NINE MILE POINT NUCLEAR STATION, UNIT NO. 1

AMENDMENT TO FACILITY OPERATING LICENSE

Amendment No. 76  
License No. DPR-63

ATTACHMENT TO LICENSE AMENDMENT NO. 76

FIGURE 3.3.2 a  
ALLOWABLE PRESSURE SUPPRESSION SYSTEM  
4 FOOT DOWNCOMER SUBMERGENCE

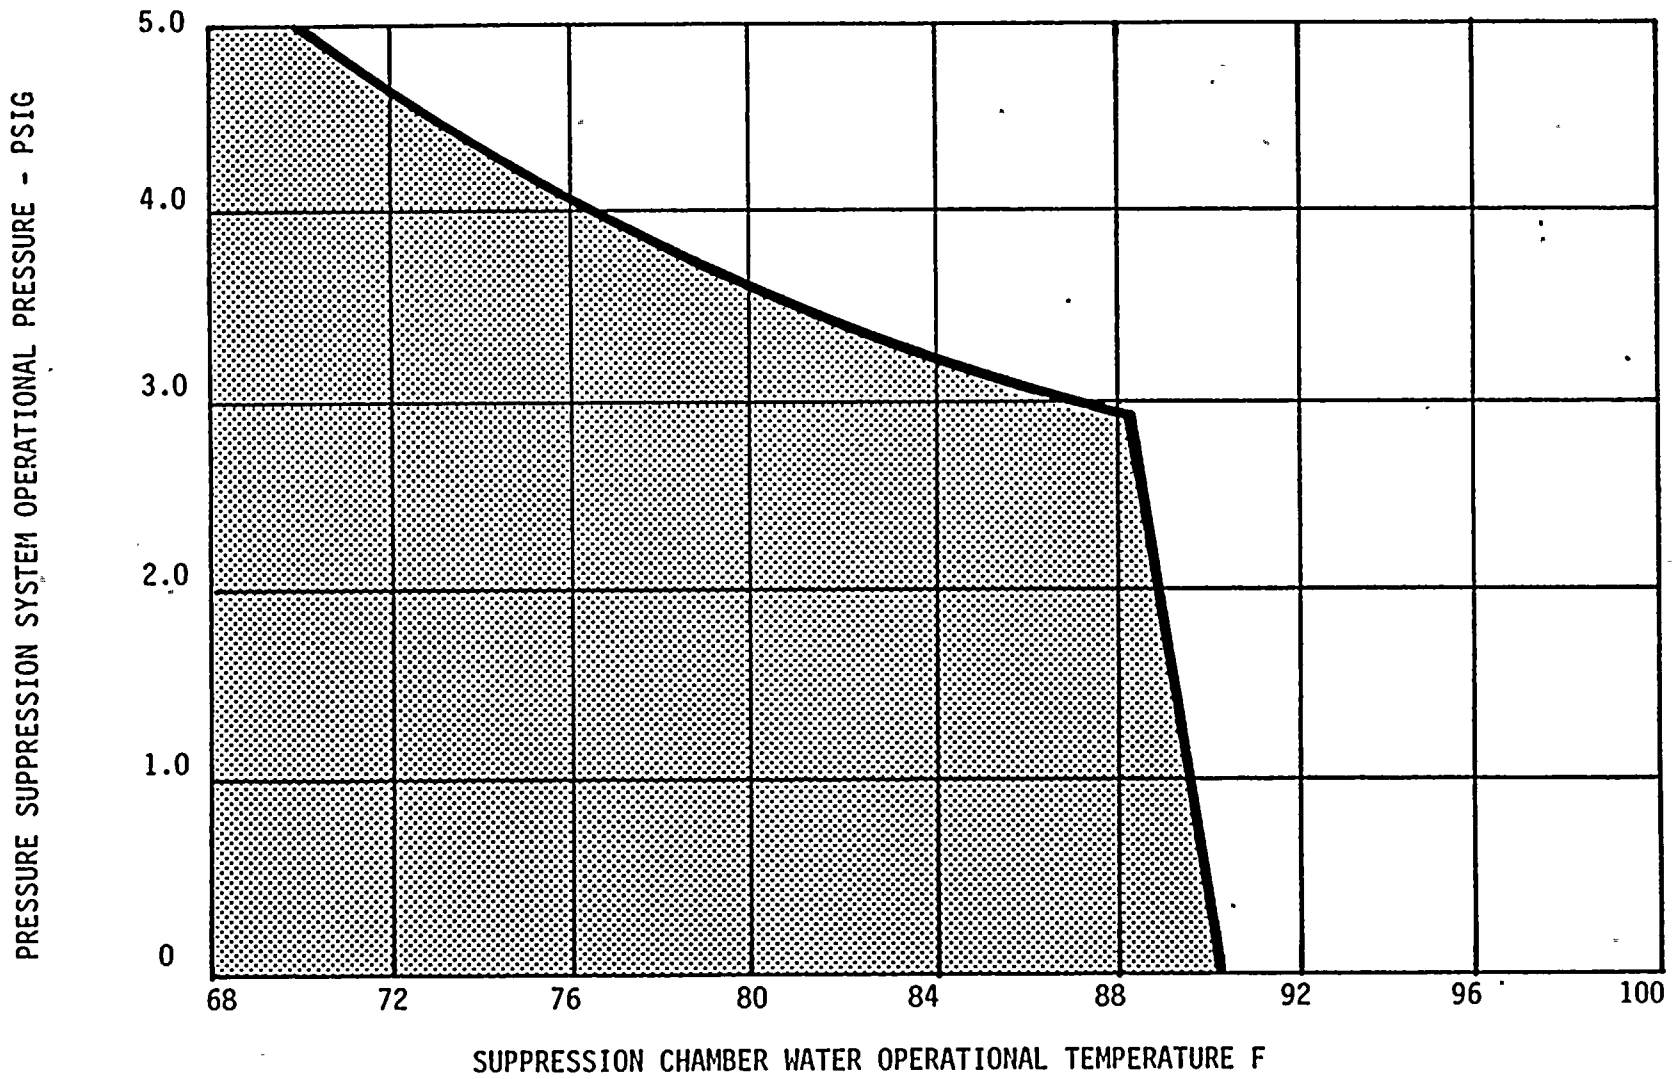
- a. The downcomers in the suppression chamber shall have a minimum submergence of three feet and a maximum submergence of four and one half feet whenever the reactor coolant system temperature is above 215F.
- b. During normal power operation, the combination of primary containment pressure and suppression chamber bulk pool temperature shall be within the shaded area of

(1) Figure 3.3.2a when downcomer submergence is greater than or equal to 4 feet, or (2) Figure 3.3.2b when downcomer submergence is greater than or equal to 3 feet but less than 4 feet. If these temperatures are exceeded, pool cooling shall be initiated immediately.
